TA-1	COVER SHEET
TA-2	PLANS
M-1	MECHANICAL PLAN
P-1	PLUMBING PLAN
E-1	GENERAL NOTES AND LEGEND
E-2	THIRD FLOOR POWER AND LIGHTING PLAN

PROJECT:
Cornerstone Family Practice
Suite 300

CITY OF AURORA
BUILDING DIVISION
APPROVED AS NOTED
DATE: APPROVED JAN 08 2010

Cover Sheet
TA-1

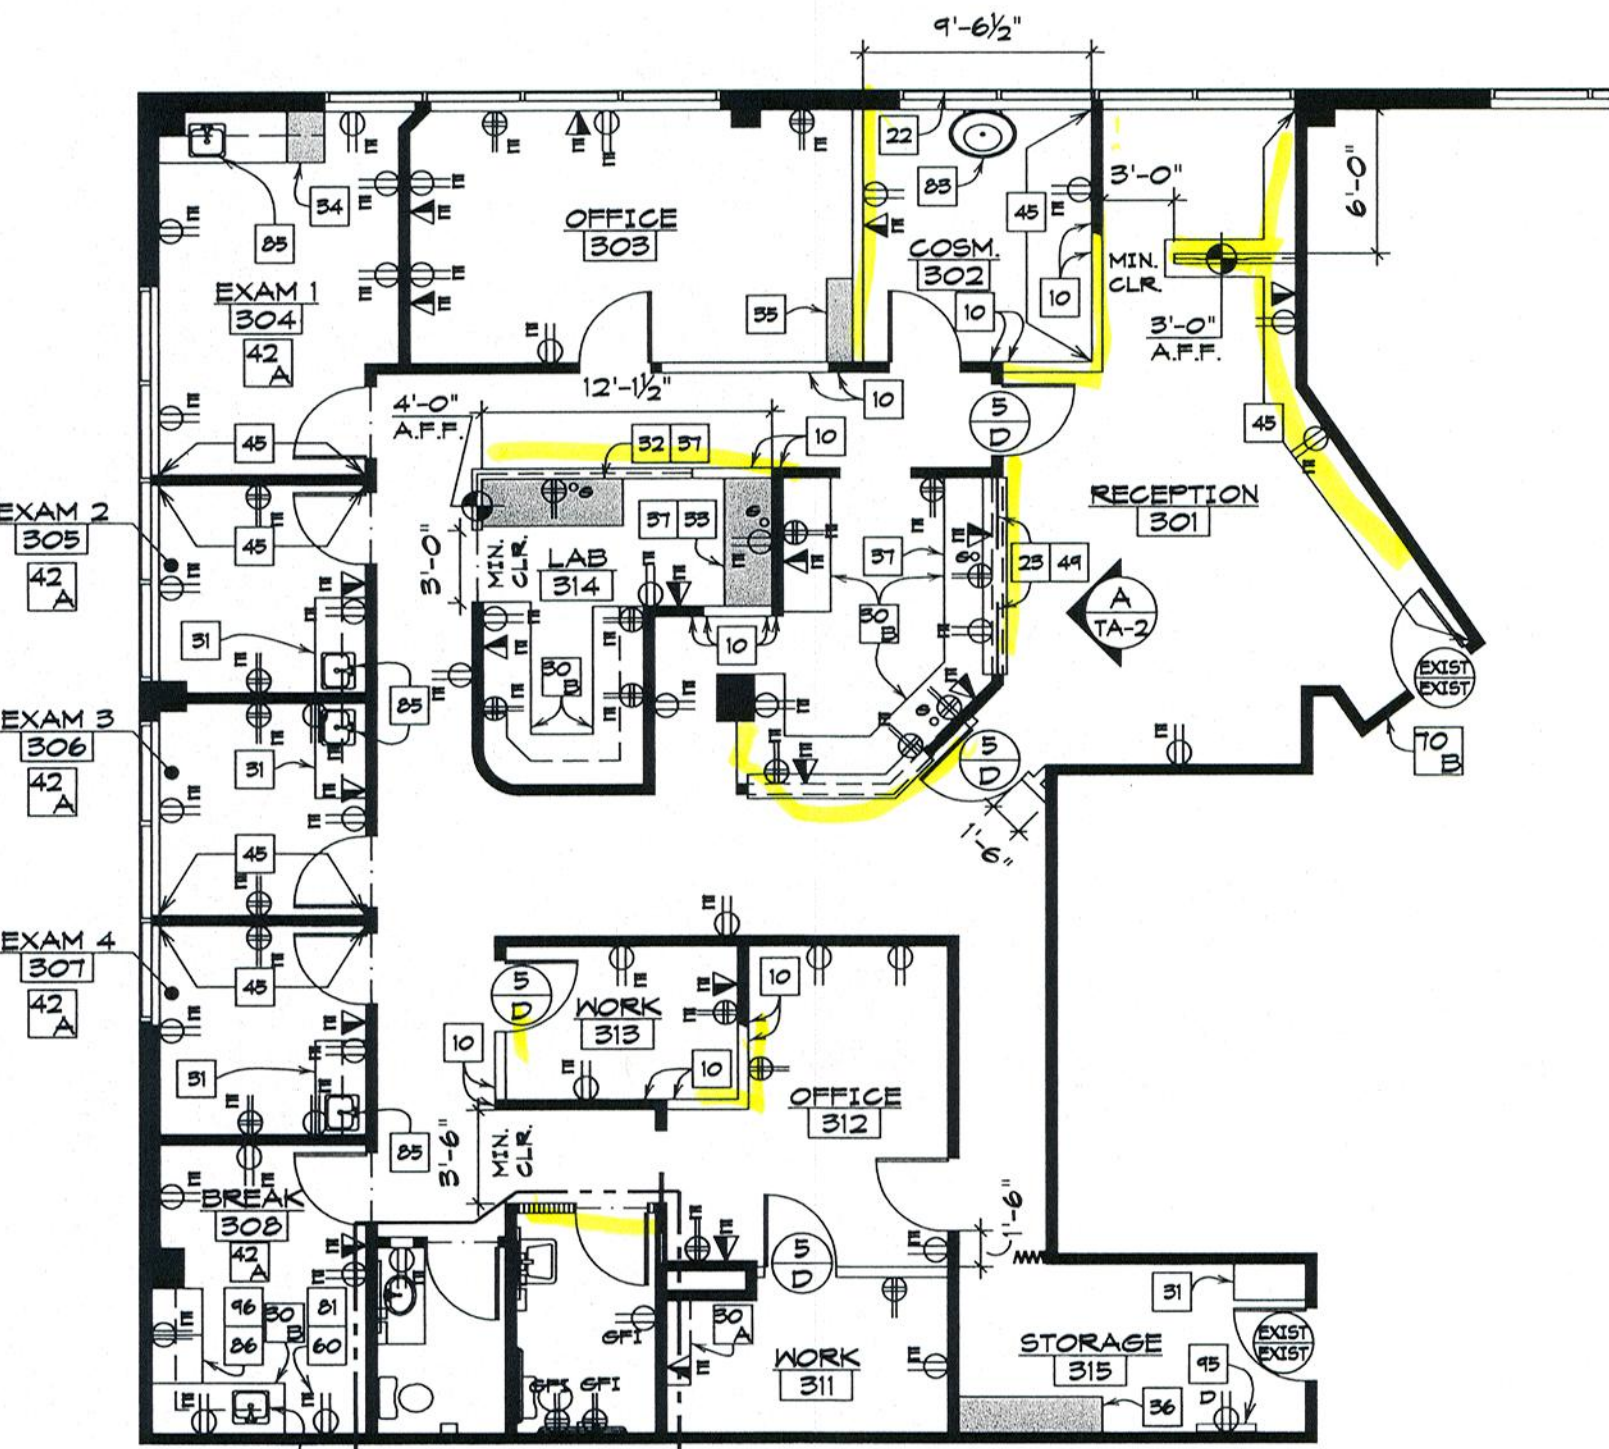
Failure to follow the approved plans may result in a 2 hour minimum fee to review the field changes for code compliance.

Provide lever or other approved hardware on all new or relocated doors per 2003 ANSI A117.1.

Structural plan review is limited to a general survey for code compliance. No review is implied nor was undertaken to verify structural adequacy.

Code violations that are found during inspection are required to be corrected. Permit issuance does not grant approval of a code violation per 2006 IBC 105.4.

This plan is reviewed to IBC but the existing building is NOT converted to IBC. The construction type listed is UBC, Occupancy Group is IBC.

Separate Life Safety construction documents are required for new Automatic Fire Sprinkler Systems or alterations to existing systems. Documents shall include sprinkler head locations, piping sizes, hydraulic calculations (if needed), and product cut sheets. Approval of documents is required prior to request for inspection.

Separate Life Safety construction documents are required for new Fire Alarm Systems or alterations to existing systems. Documents shall include device locations, one-line diagrams, battery calculations, and product cut sheets. Approval of documents is required prior to request for inspection.

**Third Floor Power
and Lighting Plan**

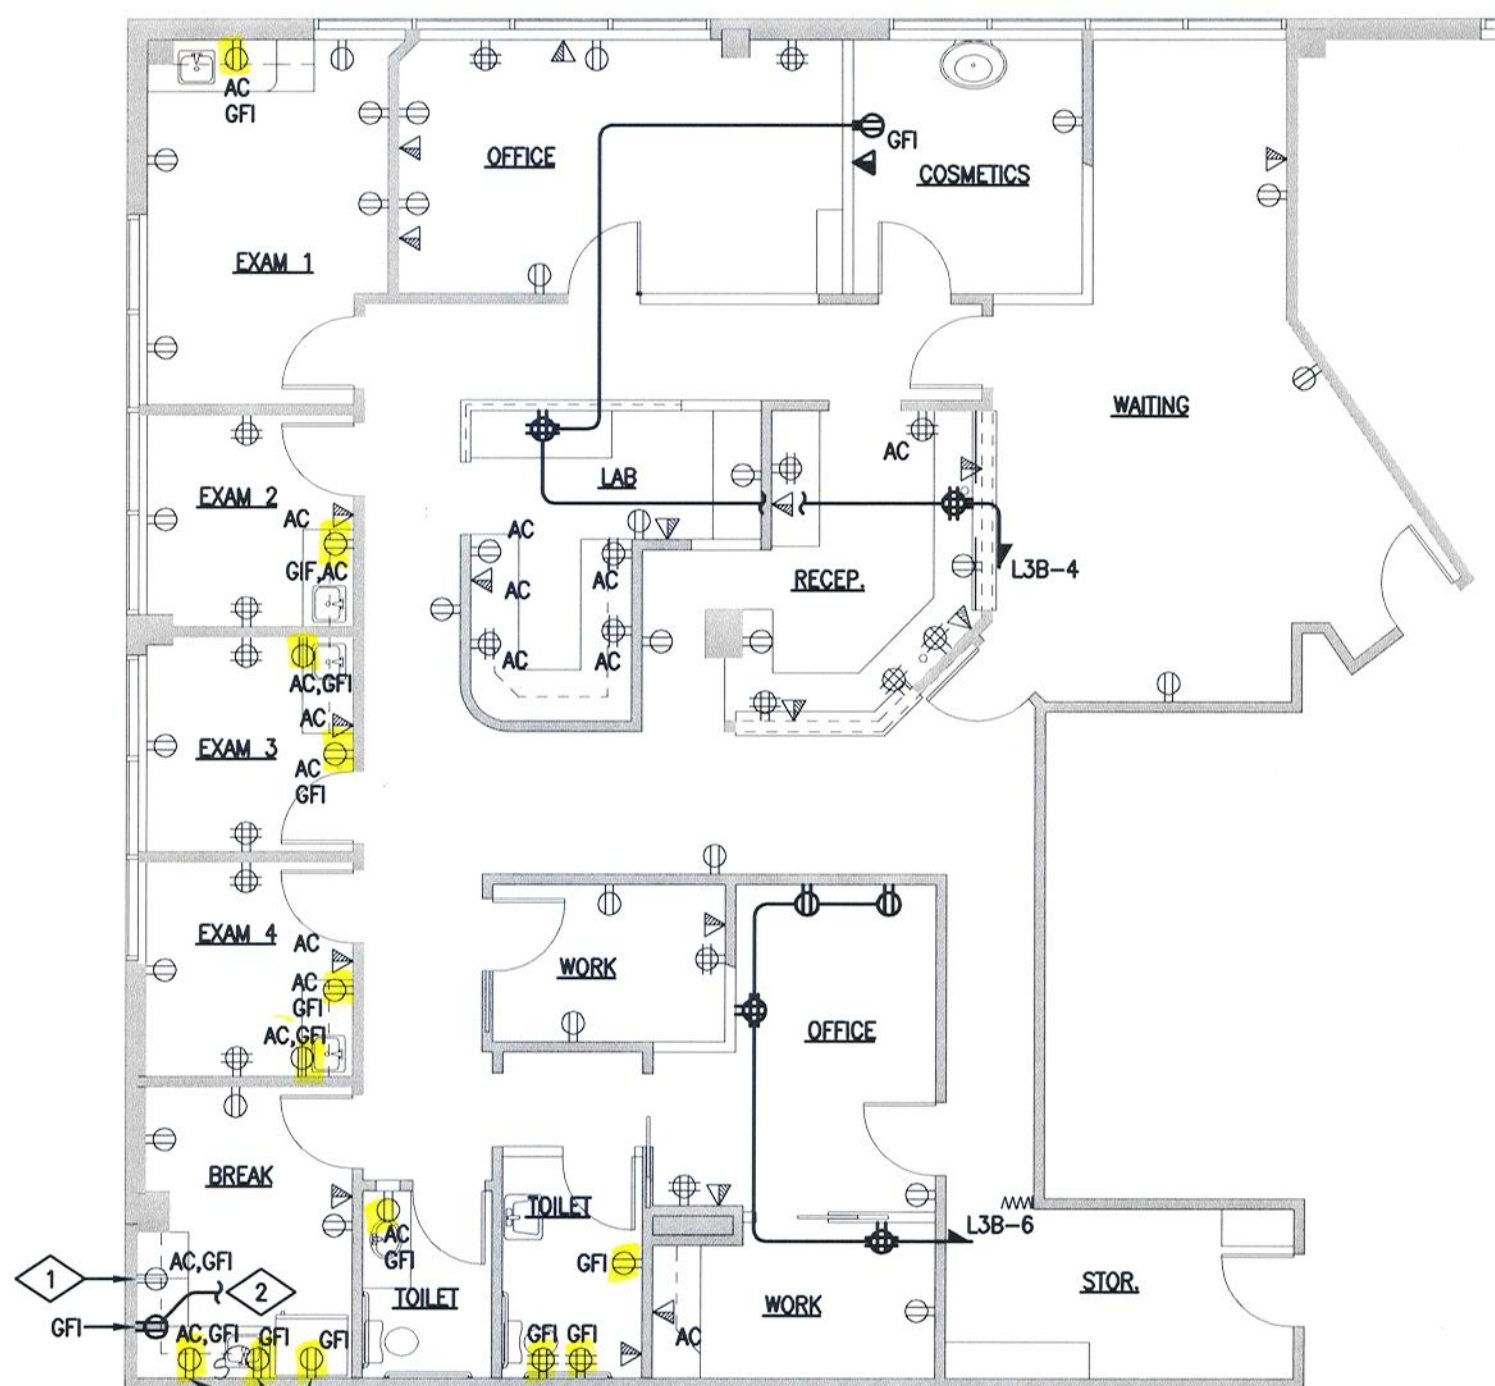
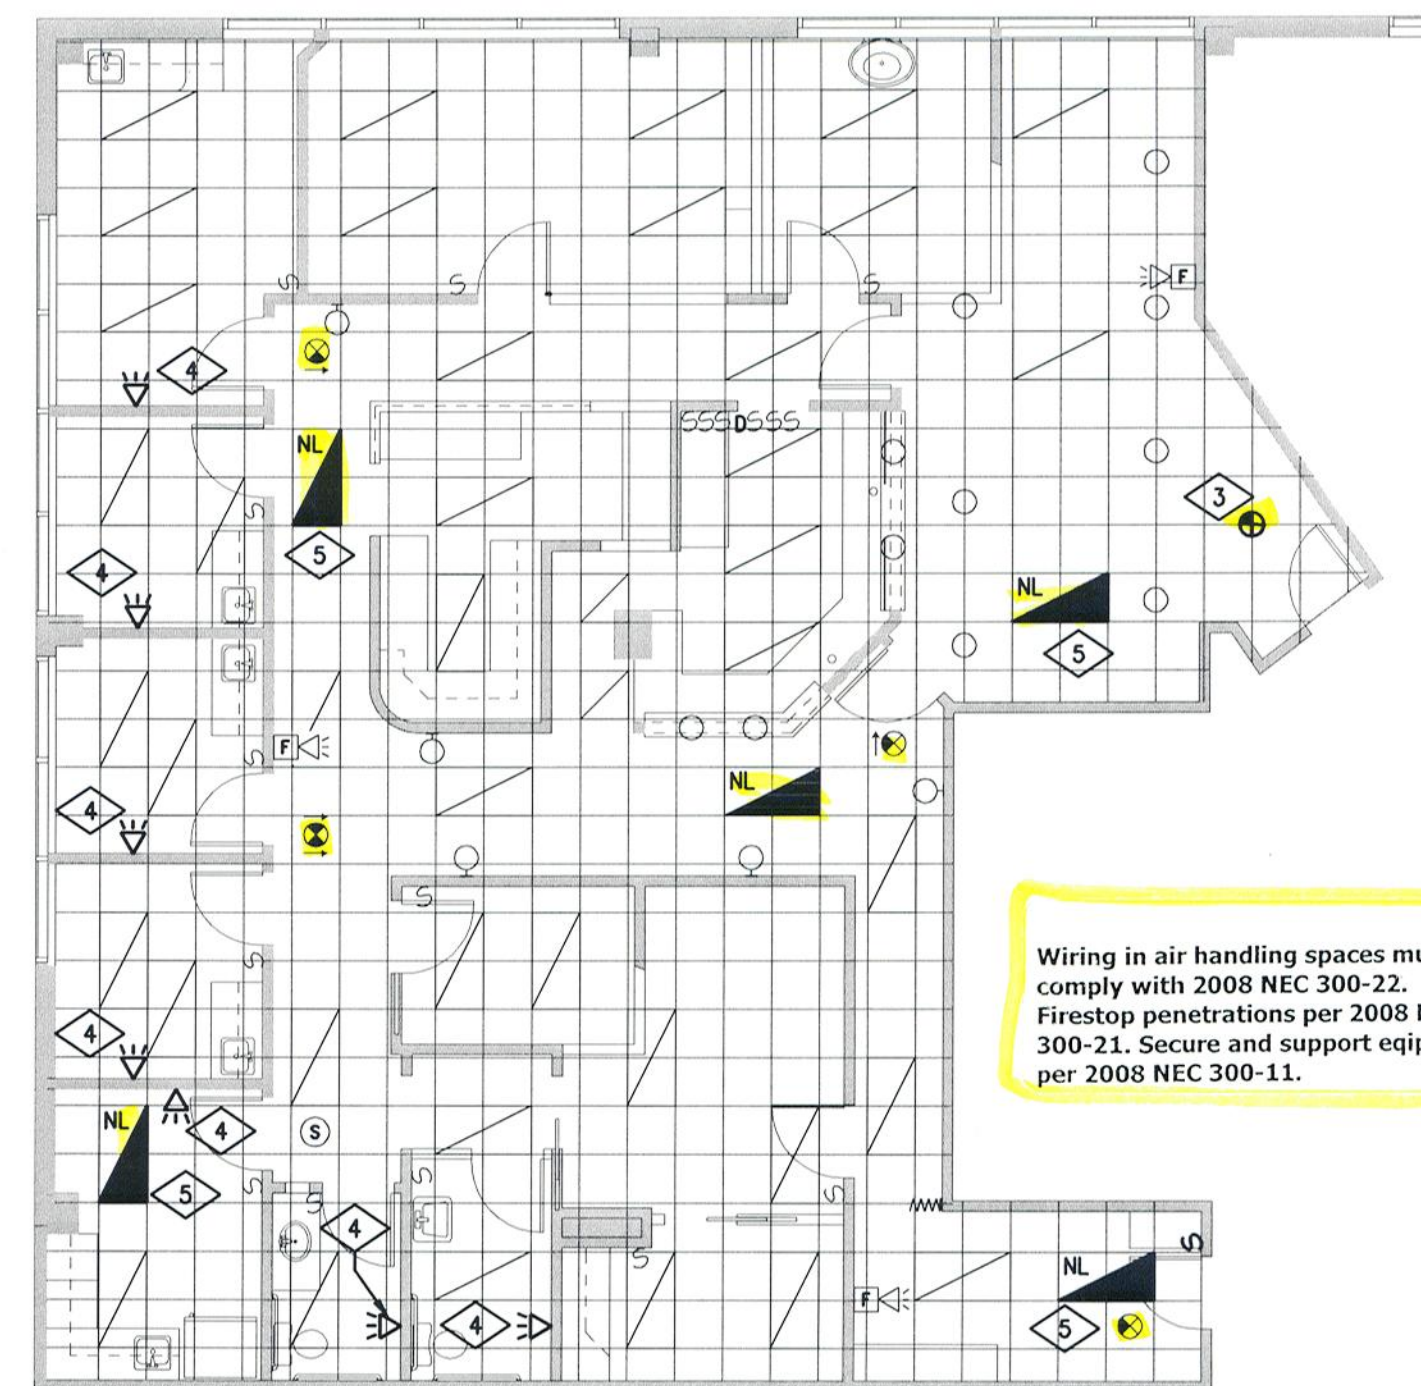
Provide emergency illumination
equipment that complies with 2008
NEC 700-12 (F) or 2008 NEC 700.

Provide visible alarm
notification appliances in
public areas and common
areas per 2003 IFC 907.10.1
and 907.10.2

110-26
Install electrical connections per
2008 NEC 110-14, identify
disconnects per 2008 NEC 110-22
and provide working space around
electrical equipment per 2008 NEC
